Addendum #4

Demolition of the Olin Bignall Aquatic Center and Old Middle School

Addendum #4- Issued November 27th, 2023

SHEET NO.
C0.51

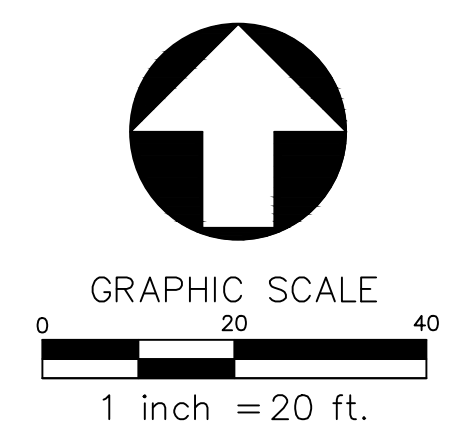
- 1. Extended Bid Due Date to Monday, December 4th, 2023 at 2:00pm.**
2. Revision 1 to sheet NO. C0.51 the Civil Engineering Drawings for the Sandy Community Building Demo
 - a. Sheet No. C0.51 / Removed note "DEMO EX. FUEL, OIL STORAGE TANK"
 - i. Updated drawing attached
3. Attached 03-97-0639 UG tank permits and info

REV	DATE	DESCRIPTION	BY
1	11/24/2023	ADDENDUM 4	MCS
